**Pre-filed Direct Testimony of
John C. Case**

**COMMONWEALTH OF MASSACHUSETTS
ENERGY FACILITIES SITING BOARD**

)	
)	
Western Massachusetts Electric Company)	EFSB 08-2/D.P.U. 08-105/D.P.U. 08-106
)	
)

PRE-FILED DIRECT TESTIMONY OF JOHN C. CASE

**Shawinigan S/S to
Ludlow S/S
Reconductor Map**

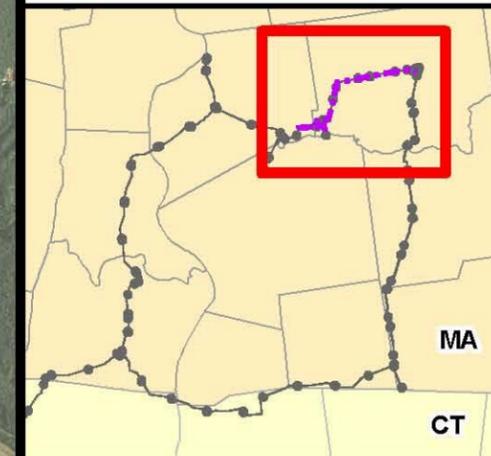
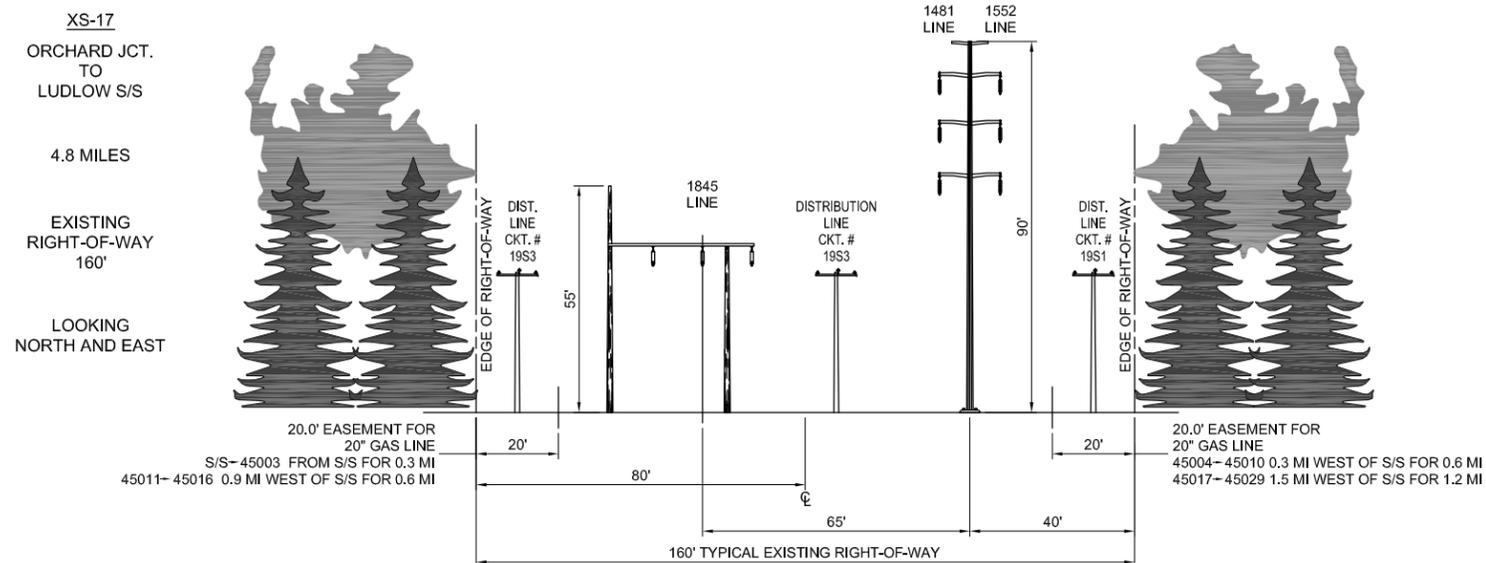
- 5 2. **Re-use of Towers:** After the use of high-temperature, low sag ACSS conductors
6 was explored, it was determined that the existing monopole steel structures carrying
7 circuits 1481 and 1552 and 1426 from the Ludlow Substation to the Shawinigan
8 Switching Station can be re-used, at a cost savings to the Project of approximately
9 \$14 million. See: Exhibit WMECO-JCC-3, explained further below.

15
 16 A map of the area that will be reconducted, and revised cross sections are attached as
 17 Exhibits WMECO-JCC-3. The ability to reconductor as compared to rebuild results in a
 18 savings of over \$14 million on these circuits, as shown in the following table:

TITLE GREATER SPRINGFIELD RELIABILITY PROJECT
PROPOSED CROSS SECTIONS
ORCHARD JCT. TO LUDLOW S/S

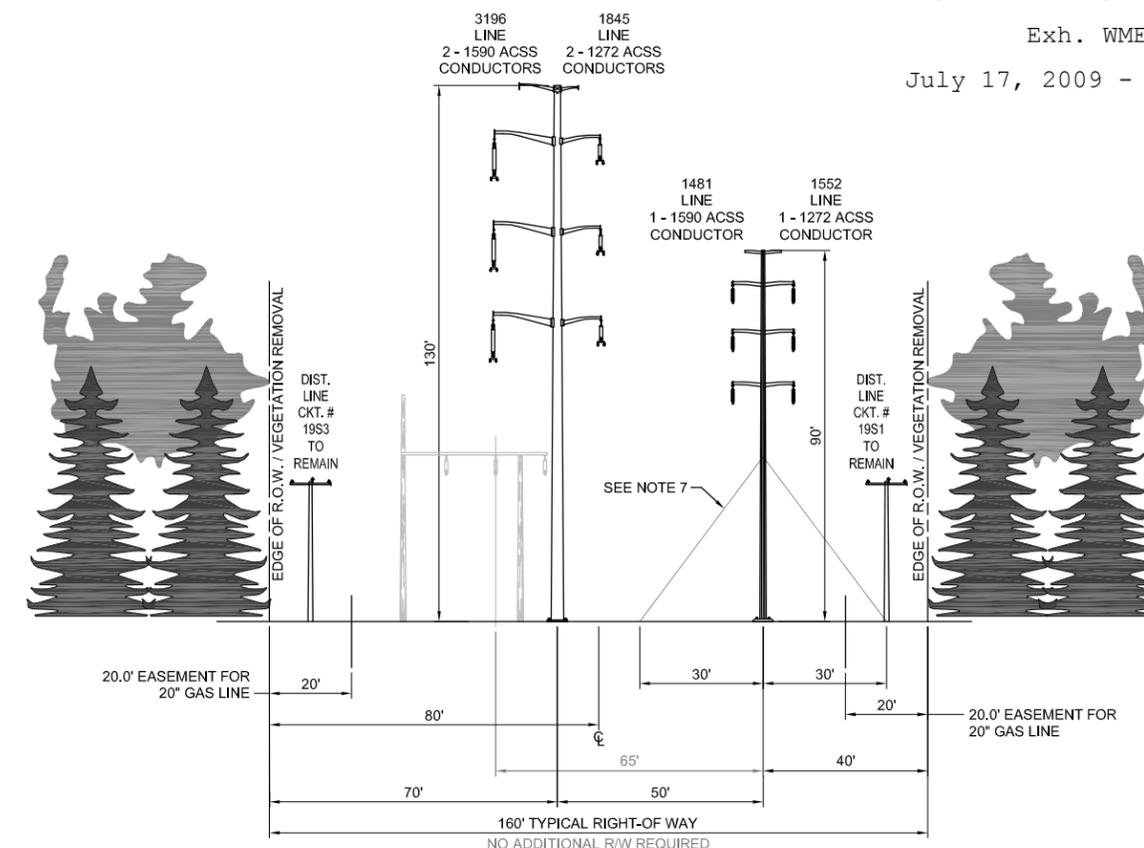
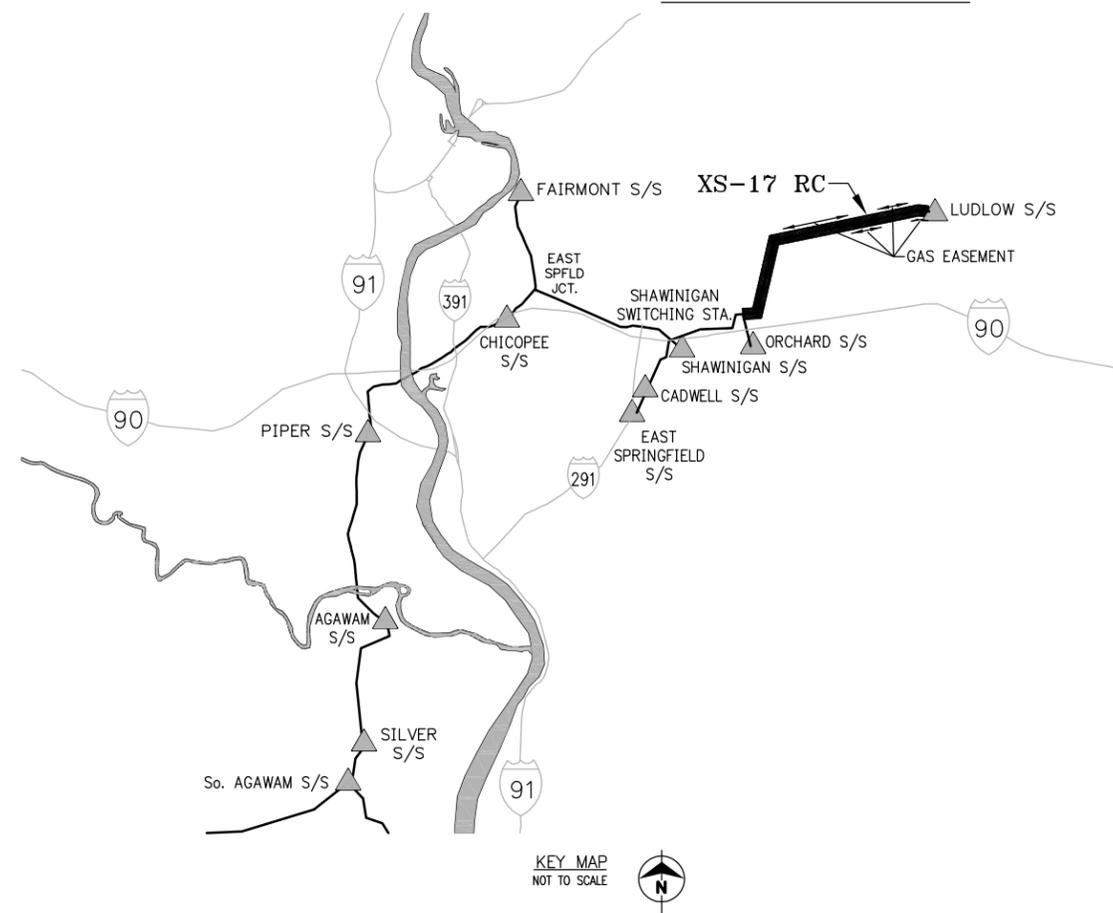
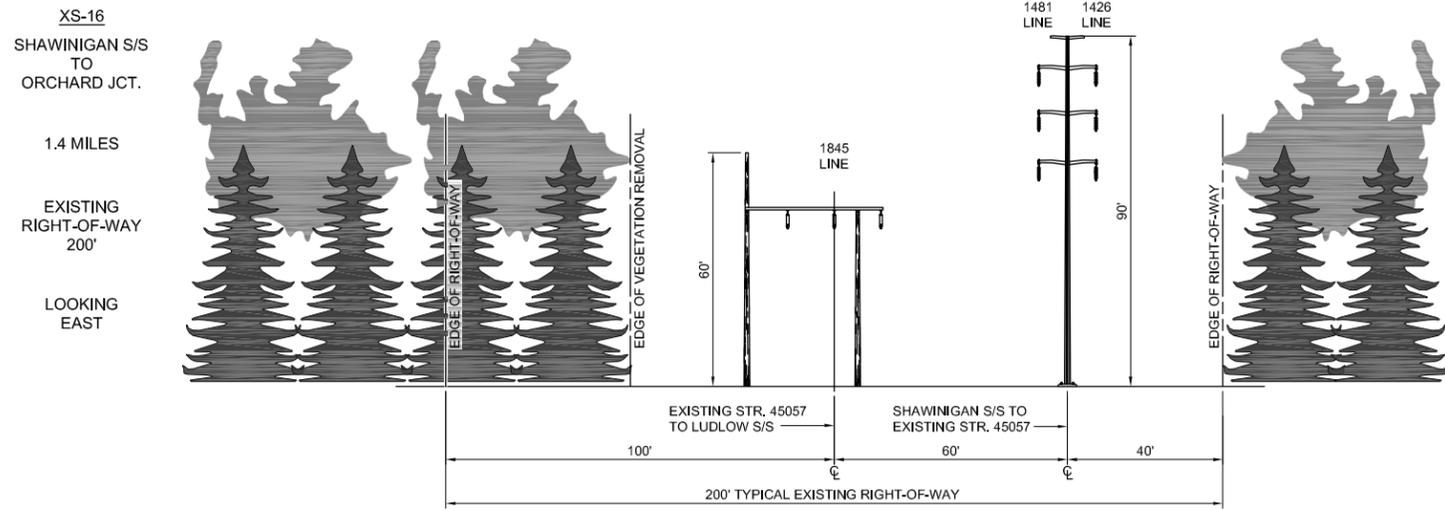
3 A. The double circuit steel poles from Ludlow – Orchard Jct. – Shawinigan carrying the 1426,
 4 1552 and 1481 lines were originally installed in the 1970's and designed for a 1272 ACSR
 5 conductor. The anticipated loads on those circuits required a bundled 795 conductor or
 6 single 1590 ACSR. These conductors were larger than the structures were designed for, and

1 the bundled conductor in particular would have introduced loads onto the structures that
 2 would have required a complete rebuild of the circuit under the original proposal. The
 3 consideration of ACSS conductor, with its greater current-carrying capacity allowed a 1272
 4 ACSS conductor to be installed which has sufficient capacity for the loads anticipated on the
 5 1426 and 1552 circuits. For the higher loads on the 1481 line, a 1590 ACSS conductor was
 6 considered. Although the margin of conductor capacity to forecast loads was less than would
 7 normally be required for a rebuild, it was determined to have sufficient margin to consider its
 8 use on these structures to see if a reconductor was feasible. The structures were analyzed for
 9 the new conductor loads and anticipated sags and were determined to be suitable for a
 10 reconductor, with minimal structure modifications. The modifications include primarily side

11 guys to be installed on most structures (for which they were originally designed), and several
 12 structure replacements (6 structures in this section, representing approximately 10% of the
 13 structures). The Table below lists the expected structure modifications required to
 14 accommodate the reconductoring from Ludlow Substation to Shawinigan Substation.

- NOTES:**
1. REMOVE EXISTING WOOD H-STRUCTURE, EXISTING DOUBLE CIRCUIT STEEL POLE TO BE RECONDUCTORED.
 2. A 0.2 MILE SECTION, 1.7 MILES EAST OF ORCHARD JUNCTION HAS 210' OF EXISTING R/W. THE REMAINDER OF THE R/W IS 160' WIDE.
 3. FINAL 0.6 MILES OF R/W CONTAINS DISTRIBUTION LINES. DISTRIBUTION STARTS BETWEEN EXISTING STRUCTURES AND MOVES TO THE SOUTH SIDE OF R/W FOR FINAL 0.3 MILES. ADDITIONAL DISTRIBUTION LINE CONTINUE ON THE NORTH SIDE OF R/W FOR FINAL 0.3 MILES.
 4. PROPOSED STRUCTURE HEIGHTS WERE DETERMINED FROM TYPICAL EXPECTED SPANS. PROPOSED STRUCTURE HEIGHTS ARE SUBJECT TO CHANGE WITH THE COMPLETION OF FINAL DESIGN.
 5. EXISTING STRUCTURE HEIGHTS ARE TYPICAL.
 6. EXISTING DISTRIBUTION LOCATION IS TYPICAL AND MAY VARY ALONG THE RIGHT-OF-WAY.
 7. APPROXIMATELY 40 EXISTING MONOPOLE STRUCTURES FROM SHAWINIGAN S/S TO LUDLOW S/S, WILL REQUIRE SIDE GUYS TO SUPPORT THE NEW CONDUCTOR.

**AGAWAM - WEST SPRINGFIELD
 CIRCUIT SEPARATION PROJECT
 AGAWAM SUBSTATION
 TRANSMISSION ALIGNMENT
 PROSPECT STREET - ALTERNATIVE 3
 UNDERGROUND ONE AWS CIRCUIT**

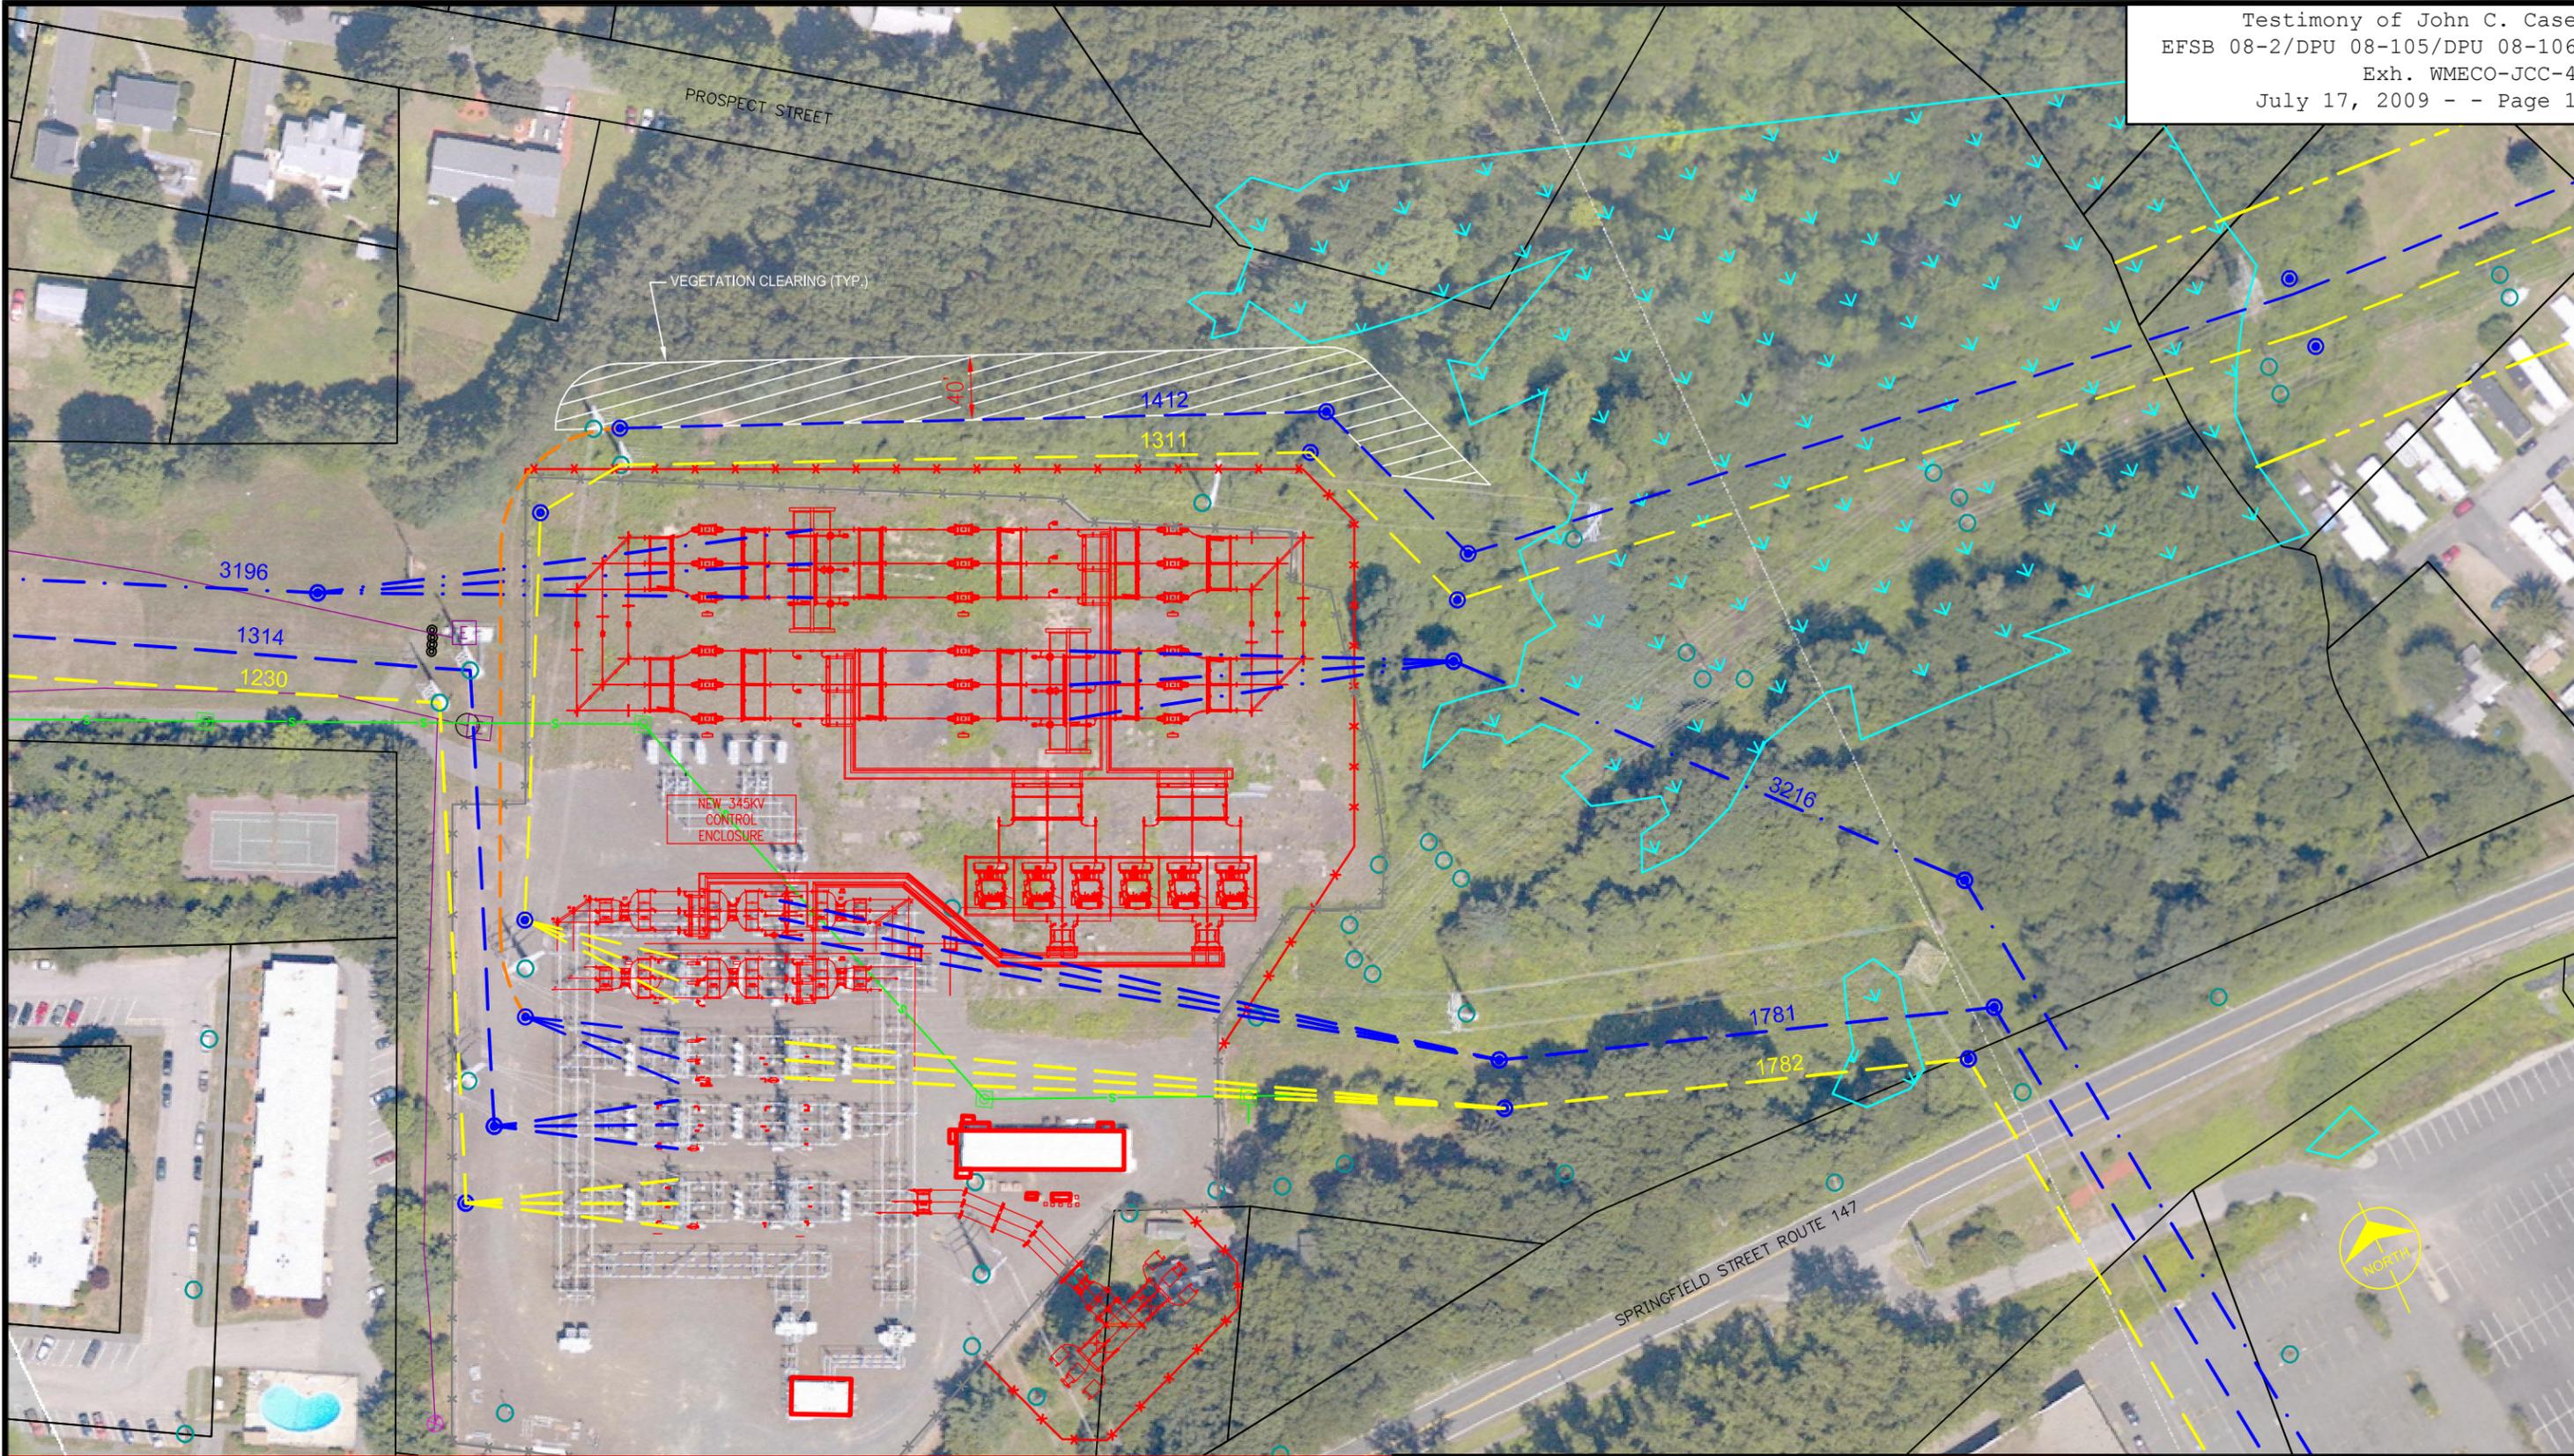
3 A. Soil borings from the site and civil analysis revealed a concern with the ability for the soil
4 conditions to support the planned retaining wall on the north side of the site, resulting in a
5 redesign of the layout of the station to provide a general shift of the equipment in the
6 southerly and easterly direction. This drove a need to redesign the station, shifting the
7 transformers and adding gas-insulated transmission line (“GITL”) lengths and relocating the
8 115-kV capacitor banks to the far southern end of the yard, outside of the existing fenced
9 area. The property that the capacitor banks will be located on is currently owned by
10 WMECO and has an abandoned house on it that will be removed. This change causes the
11 345-kV additions at Agawam Substation to be located predominantly within the existing
12 fenced area, and farther away from the residential areas to the north and west of the station.

14
15 As a result of the general shifting of the equipment, it was determined that the overall design
16 of the lines should be re-examined. It was found that overall line entry design would be more
17 reliable, as well as easier to construct and maintain, if circuit 1412 were to be constructed
18 underground for a short distance as its “getaway” from the substation. Reliability was
19 improved since a failure of the shield wire, as the new 345-kV circuit crossed over the 115-
20 kV lines 1412 and 1311, could not cause an outage of the underground line 1412. With one
21 line underground in this short segment, more distance between the overhead circuits was
22 possible, contributing to both the ease of construction and maintenance during operations.
23 With the undergrounding, the separation of the overhead circuits did not satisfy NU
24 Standards for clearance between circuits. By taking the 1412 line underground along the

25 north end of the substation (see Exhibit WMECO-JCC-4, attached), in addition to foregoing
26 benefits, the amount of tree clearing was reduced to the north of the substation. The
27 combination of the undergrounding of the 1412 circuit and the shift in the substation
28 arrangement described above allows several existing 115-kV structures to be re-used and
29 minimizes impacts to residents around the substation. The 1412 line proposed for
